ADDENDUM NUMBER ONE

DATE OF ISSUANCE: August 16, 2019 **PROJECT NUMBER:** 19028

PROJECT: Snowbasin Clinic
3925 Snow Basin Road
Huntsville, Utah 84317 **ARCHITECT:** JRCA Architects, Inc.
577 South 200 East
Salt Lake City, Utah 84111

MECHANICAL ADDENDUM 1

A2
AE411
INTERIOR ELEVATION
SCALE 3/8" = 1'-0"

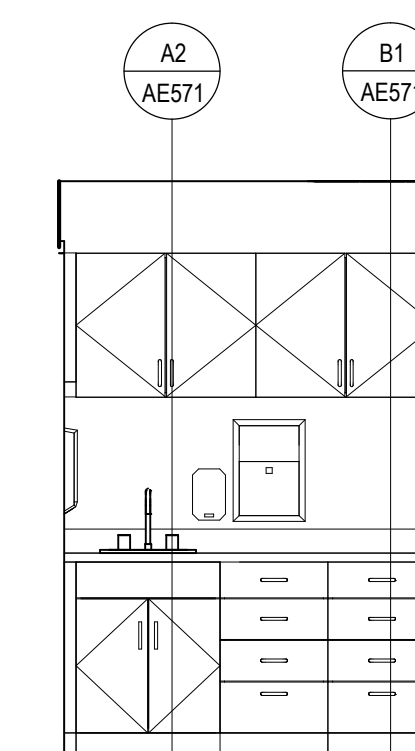
| AD1-10 | AE411 | Elevation A2/AE411 for triage area is the same layout as exam rooms, size will be adjusted for the space. |

DOOR & FRAME
 TYPES /
 SCHEDULES

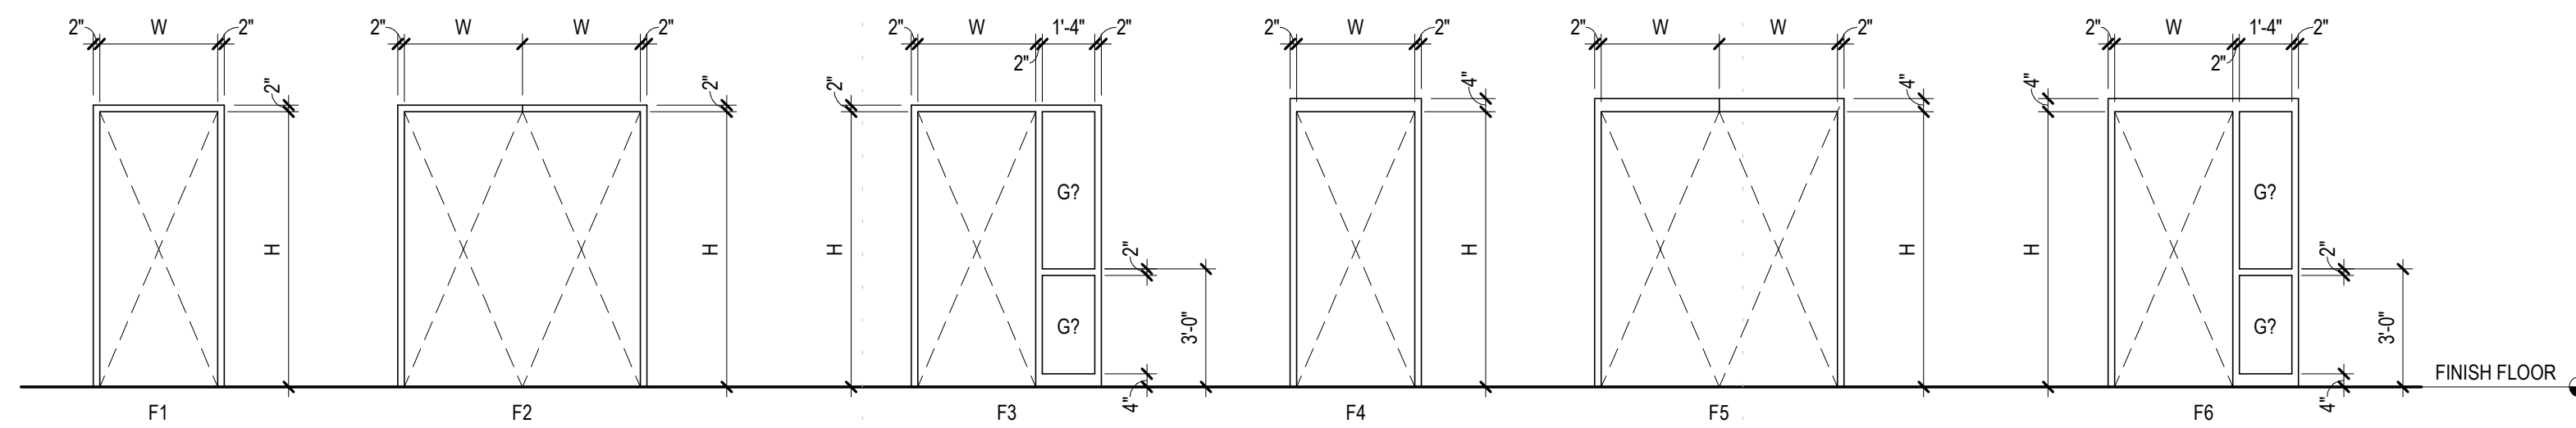
| AD1-11 | AE601 | See updated door schedule with door sizes and specifications. All sliding doors are owner purchased; contractor installed. All swing doors will be purchased and installed by contractor through Robert I. Merrill to match sliding door assemblies. Imaging room door will require lead lining. See finish schedule for door information. |

1 MAIN LEVEL MECHANICAL PLAN
 SCALE: 1/4" = 1'-0"
 PROJECT NORTH

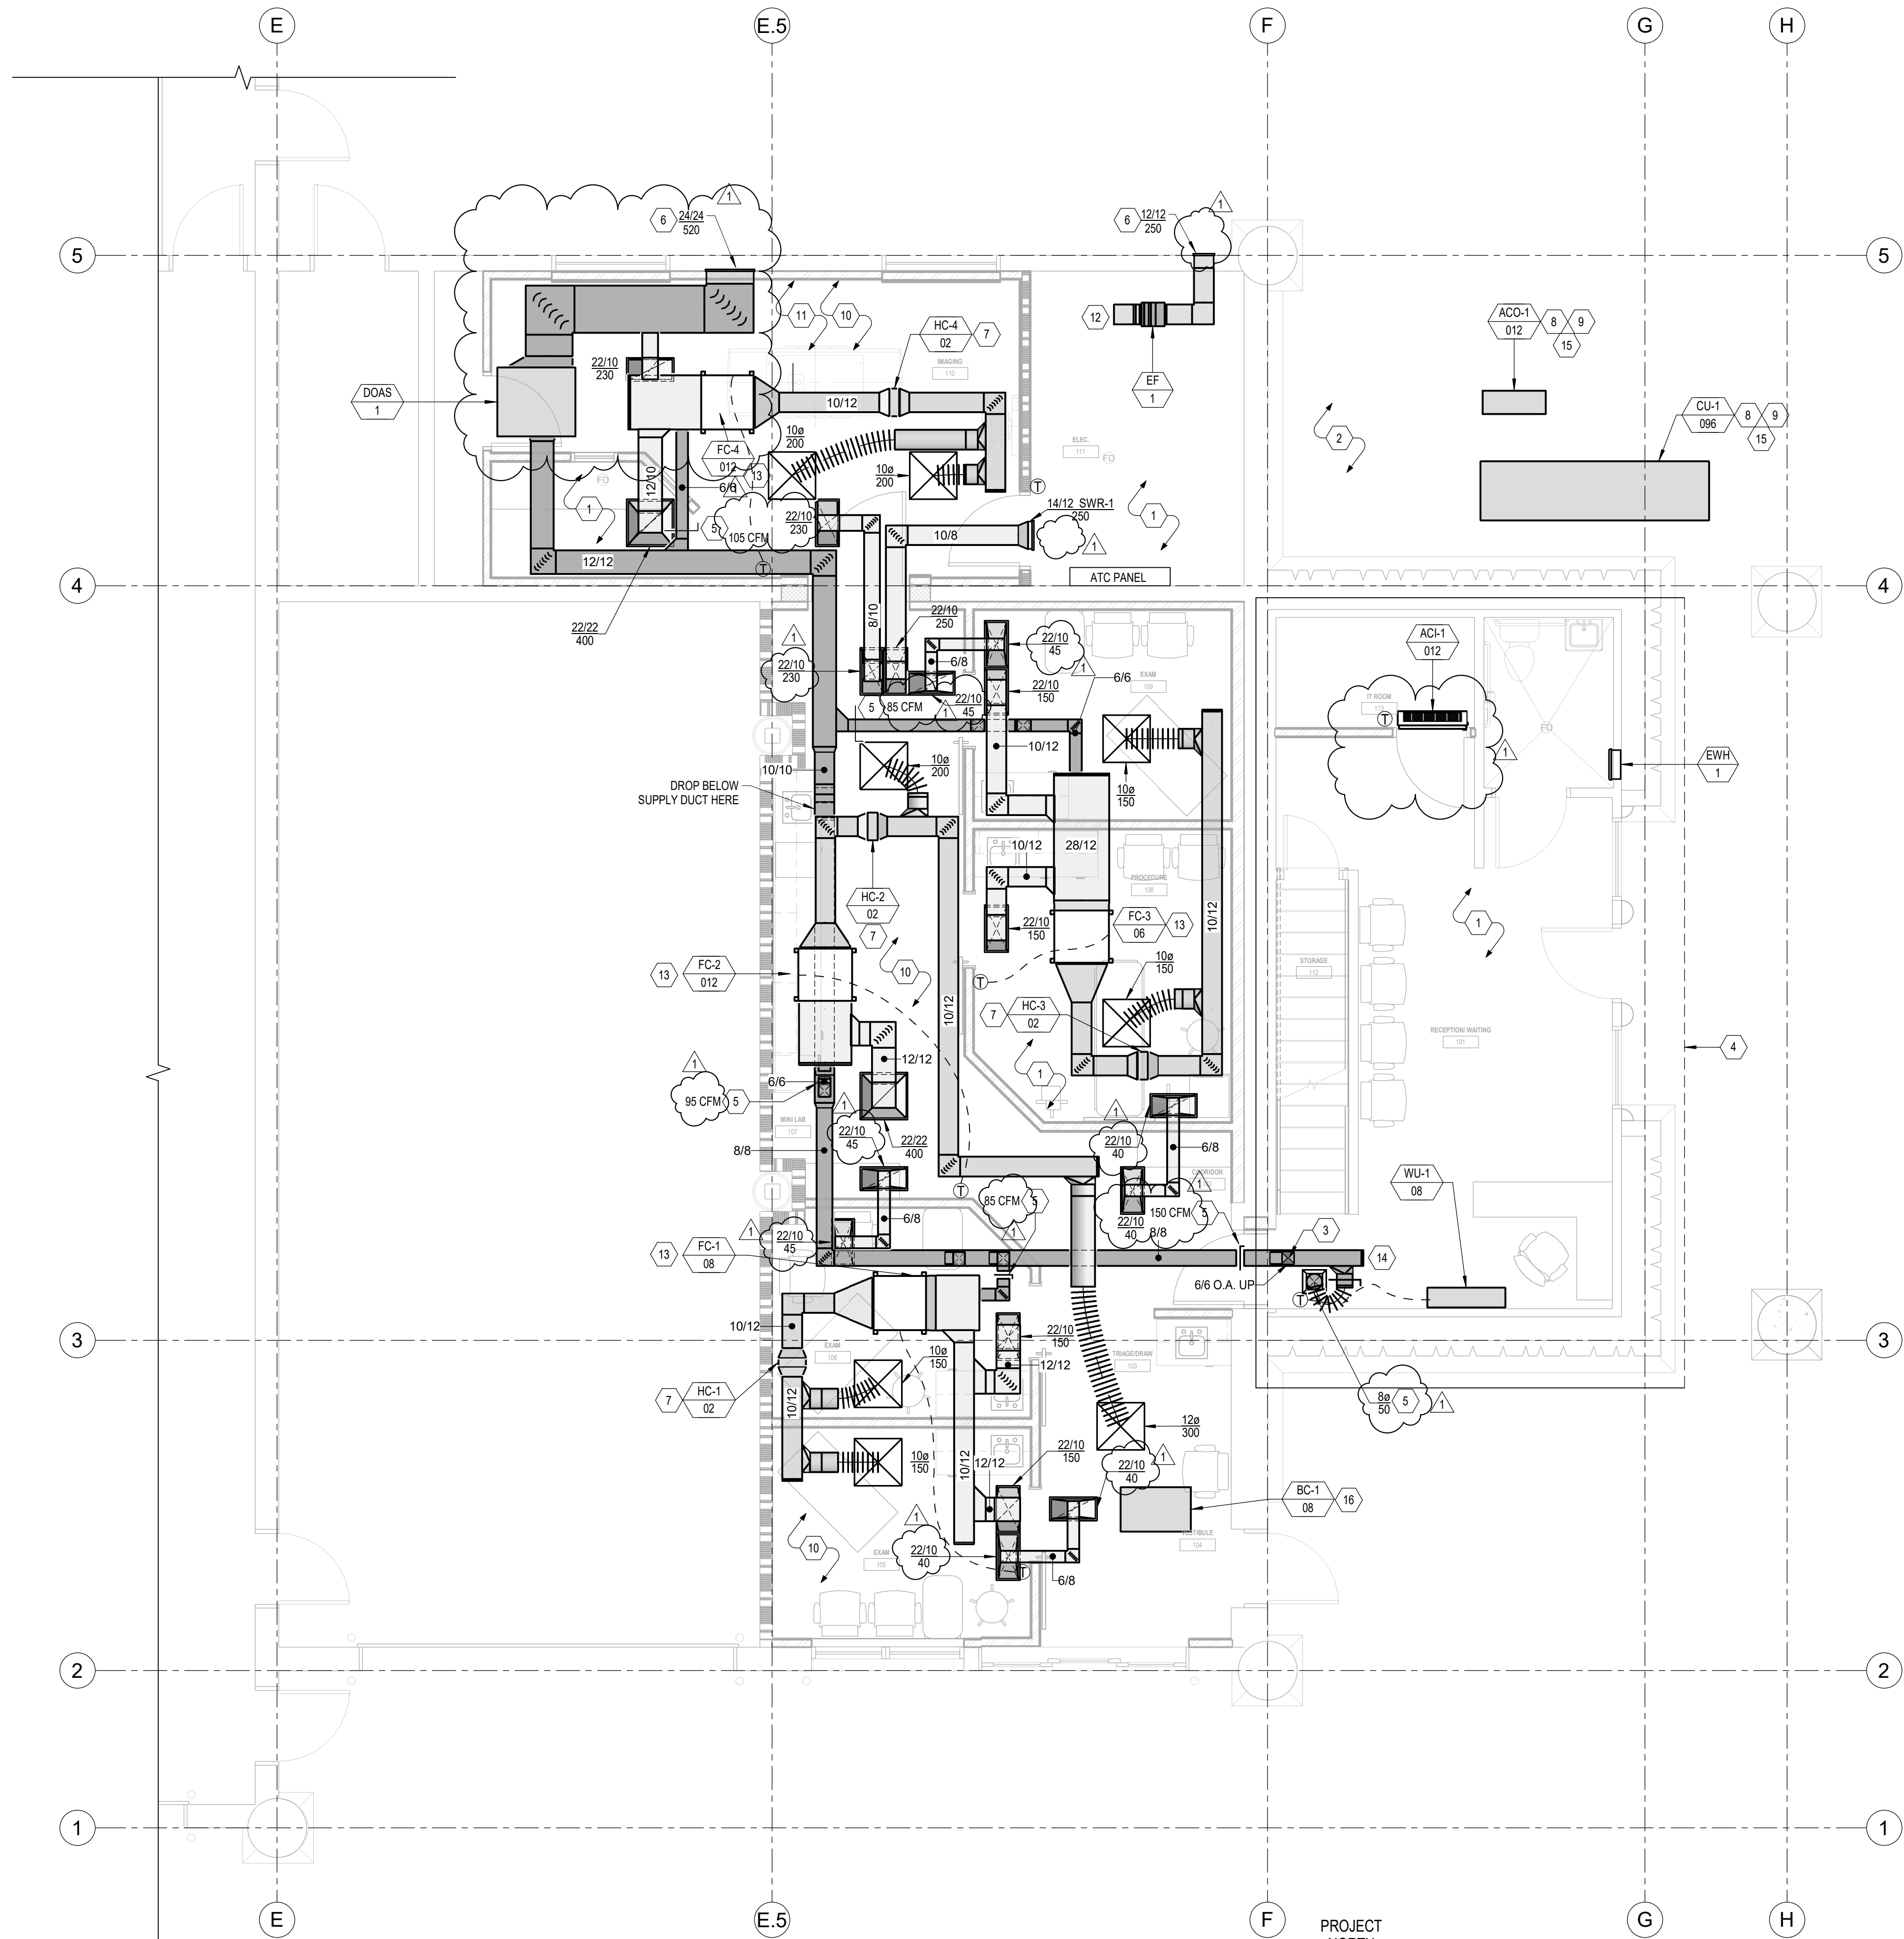
1. Refer to attached for modifications to CFMs and duct sizes.

1. Do we need a dog house and raised stand to protect the condenser from blowing ice and snow.
RESPONSE: *Please refer to the notes on the VRF Outdoor Unit Schedule – Air Cooled on MH601. Please refer to 12/MH501 for the outdoor unit mounting.*
2. The drawing just has the line set for the lobby HVAC head running across the ceiling. Do we want this exposed or in a raceway of some sort.
RESPONSE: *We take no exception to this being exposed.*
3. Can the lobby HVAC unit be relocated to the south wall so that it will have a long throw posed to short one.
RESPONSE: *Please refer to MH101 in Addendum 1.*
4. We need to verify the location of the outside air fan. Moving the fan further down the wall was discussed in the walk through.
RESPONSE: *Please refer to MH101 in Addendum 1.*
5. Can we get a spec for the HVAC in the ski patrol area.
RESPONSE: *Please refer to MH101 keyed note 4.*

MECHANICAL SCHEDULES

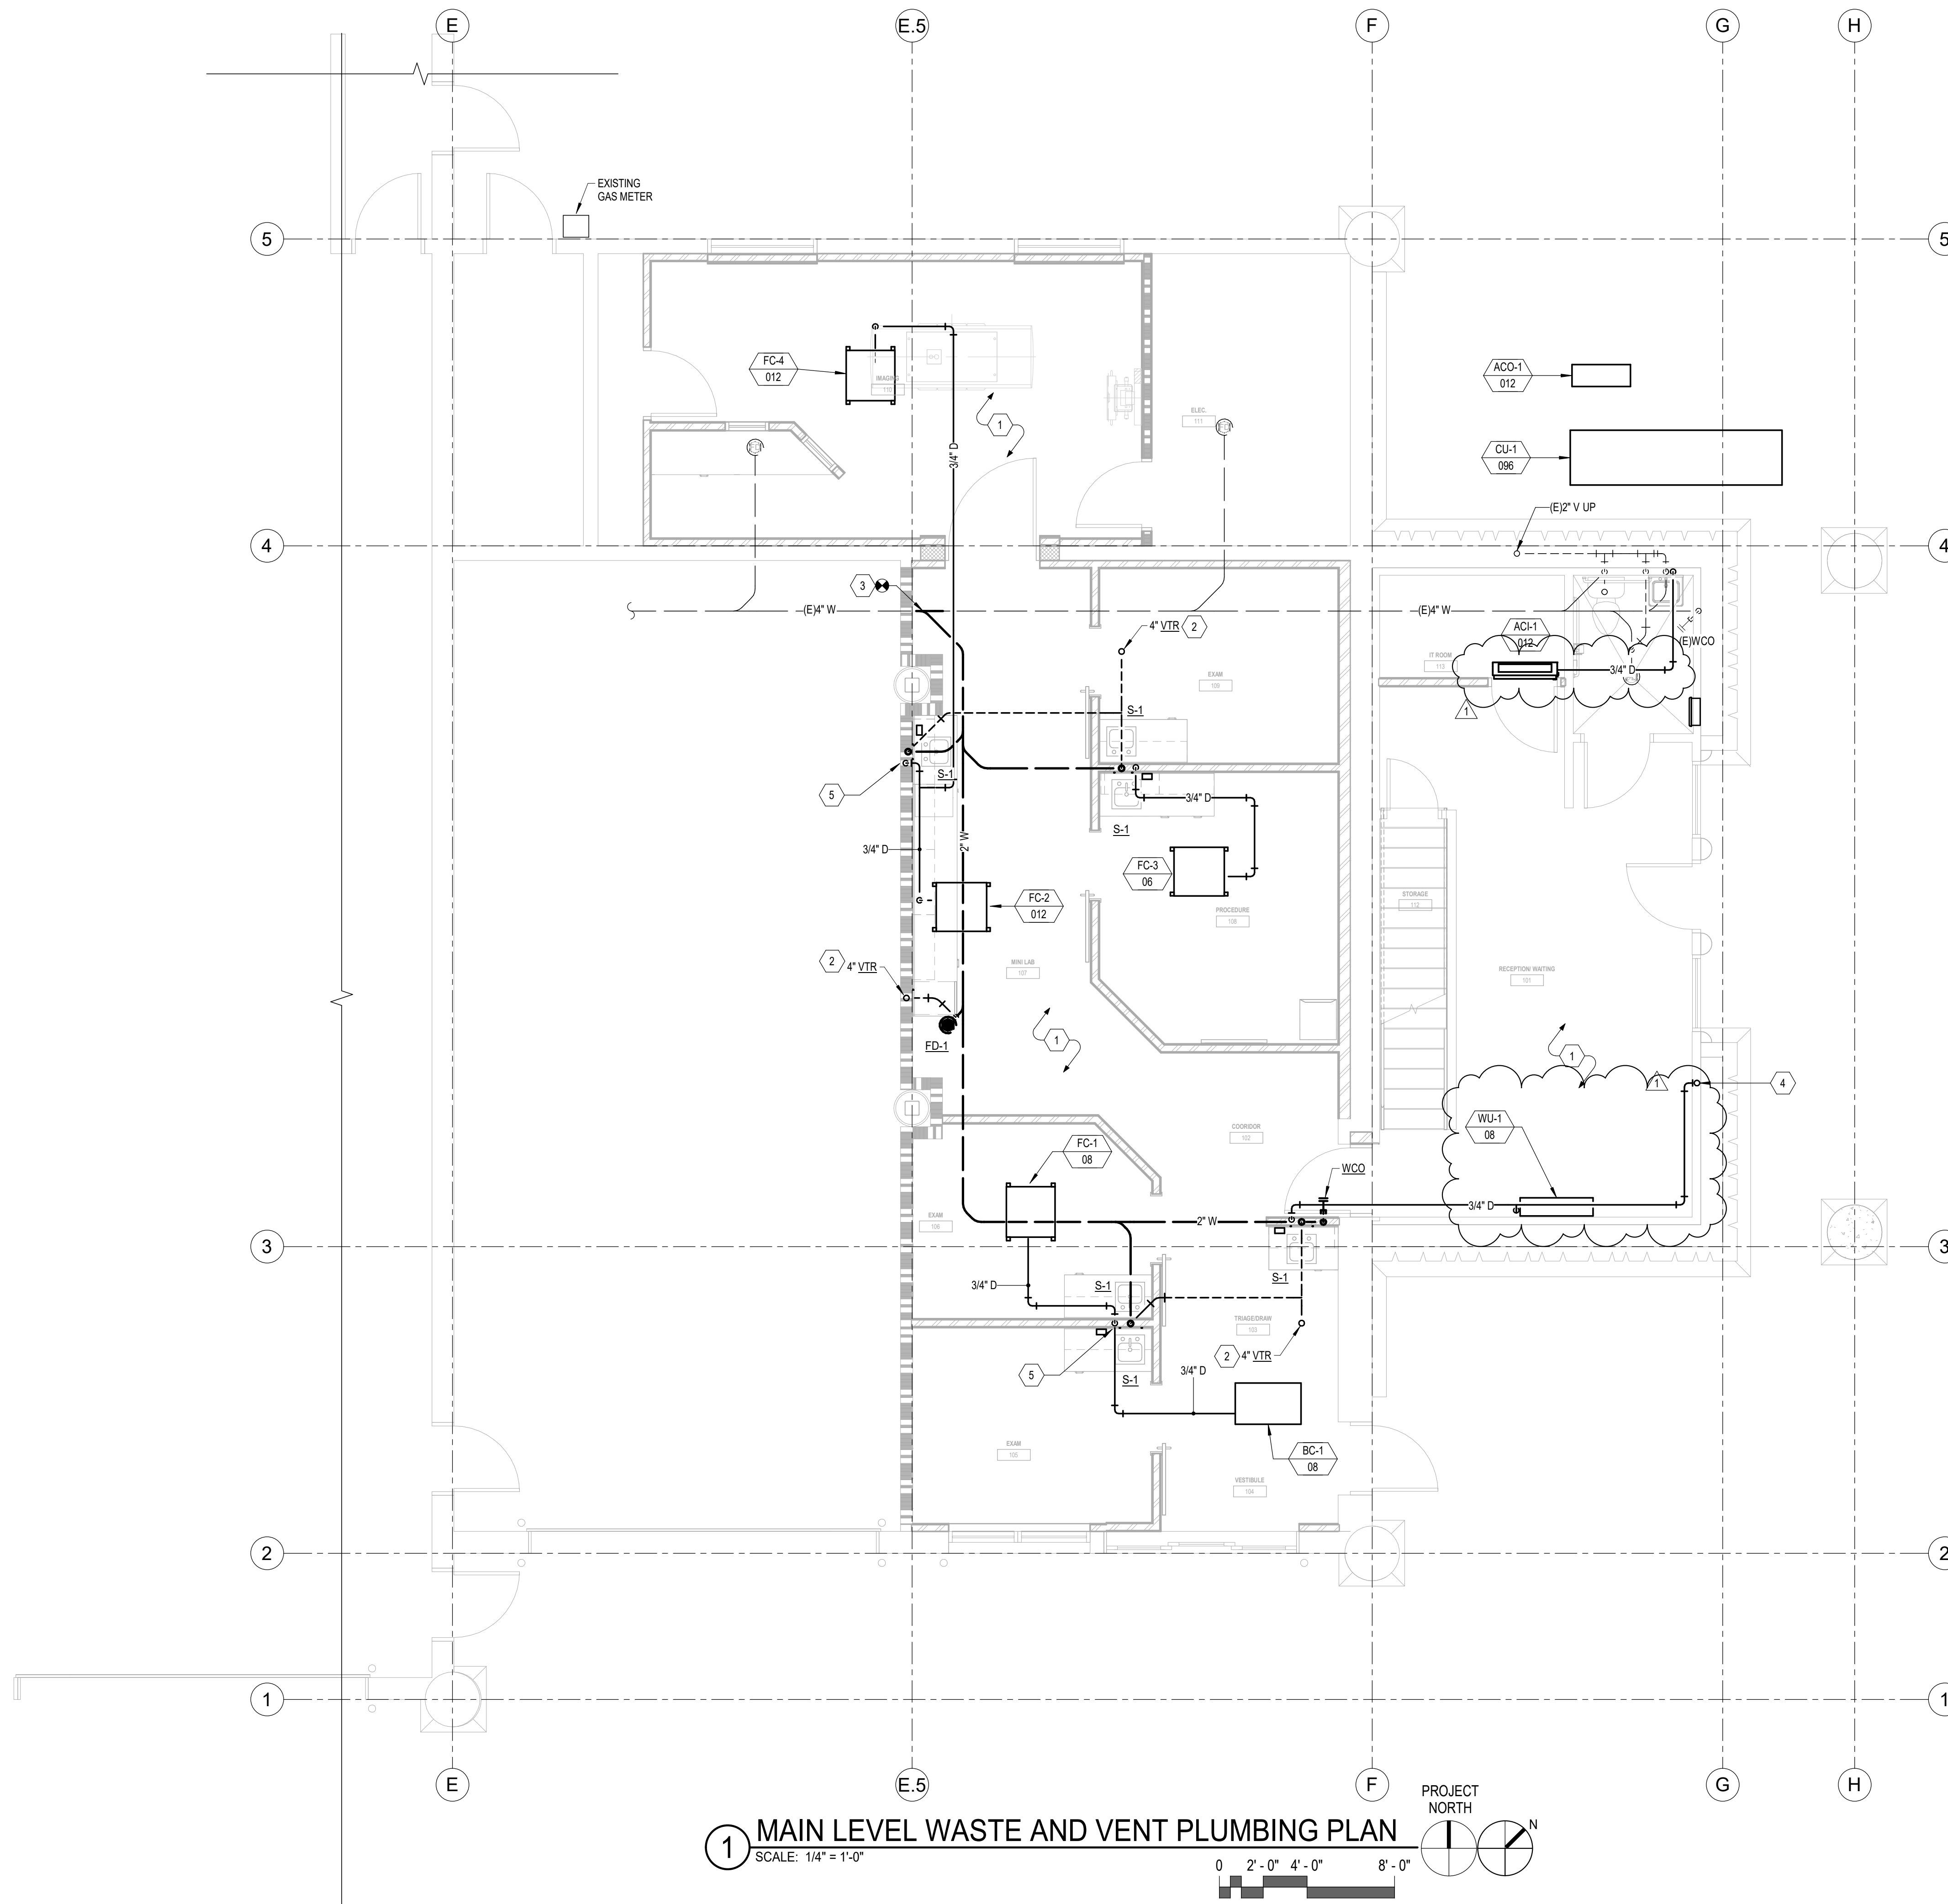
1. Refer to attached for modifications to the Electric Heating Coil Schedule.
2. Refer to attached for modifications to the Dedicated Outside Air Unit Schedule.
3. Refer to attached for modifications to the VRF Outdoor Unit Schedule – Air Cooled.
